C S Stokes and Associates Limited

Flat 45 Grenfell Tower
Grenfell Road
London
W11 1TQ

Subject: The flat entrance door

Flat Entrance door

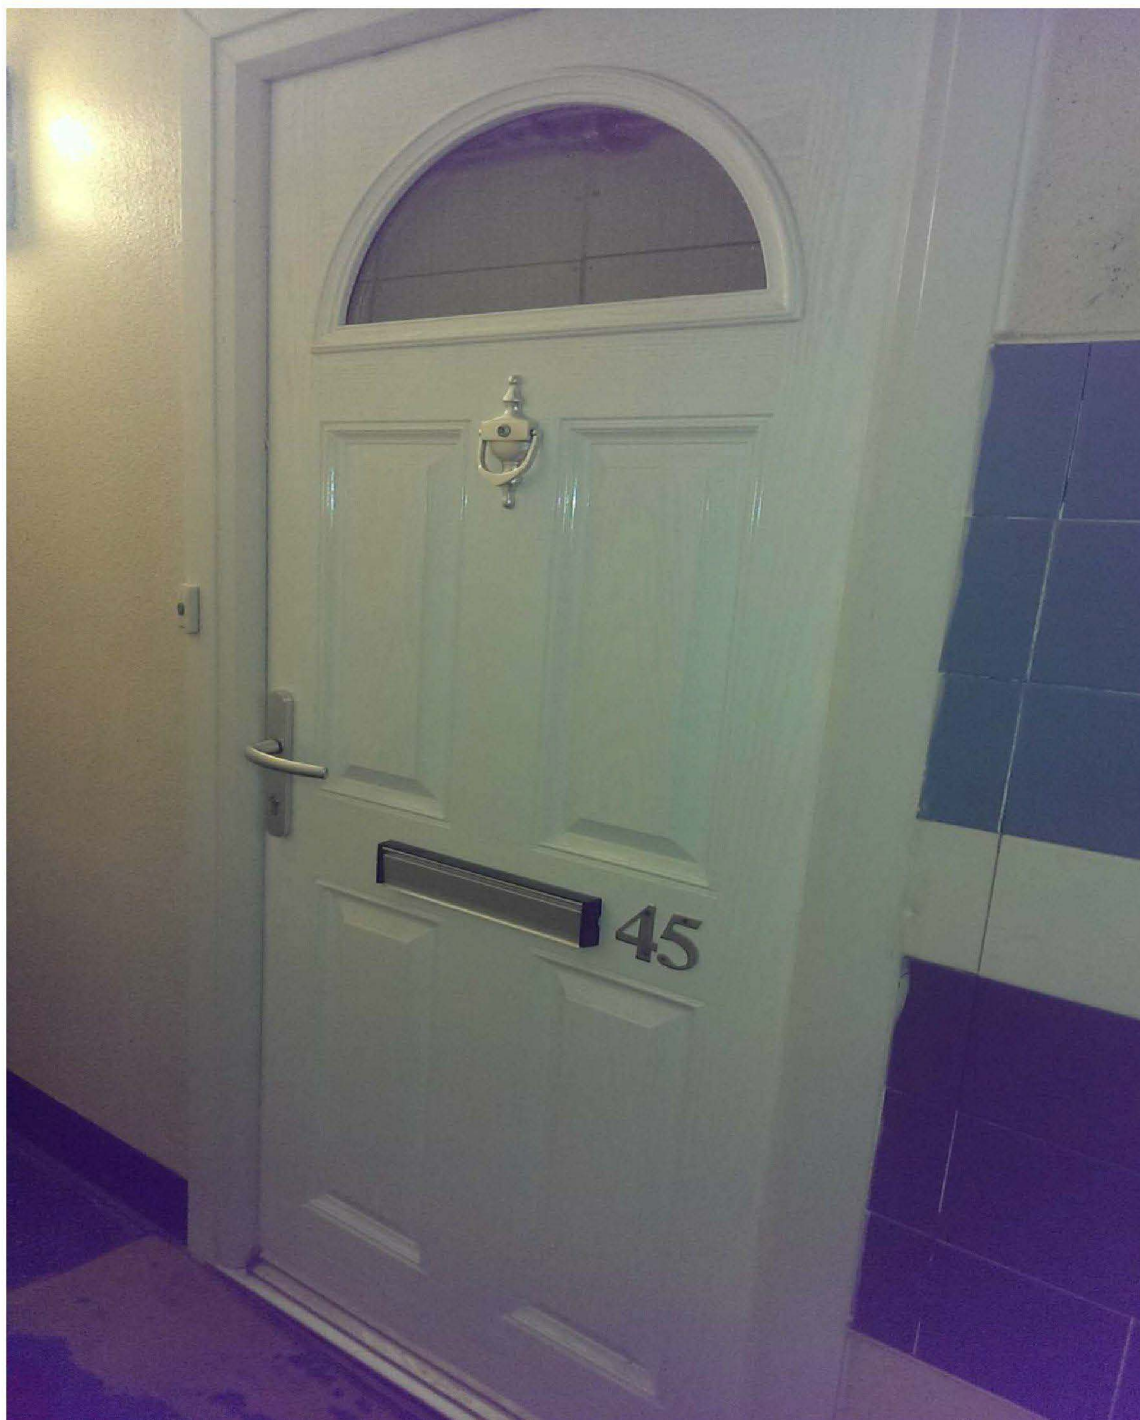
When I inspected this door yesterday the door lock is slightly out of alignment, it appears that when whoever attempted to force open this door that some slight damage has occurred. I noted that the concealed self closing device is missing from this door, two additional bolts have been fitted to the rear of the door and the inner part of the letter box is missing. Please see the relevant photographs below. There is no damage to the doors surface and no holes etc in the doors face/surface.

I believe that this door is still fully functional as a fire rated door, but adjustments should be made to the door so that the lock aligns correctly and a new inner part of the letter box should be fitted or the letter box replaced. The police officers report indicates that they recommend that a fire rated letter bag is fitted on the inner face of the door. This could be fitted at the same time as or in place of the existing letter box. I would recommend that the door manufacturers are consulted regarding the fitting of any items of additional door furniture to this certified fire rated door. This is in case any work undertaken on or to the door by non qualified persons or additional features fixed to the door invalidates any fire rated certification of the door.
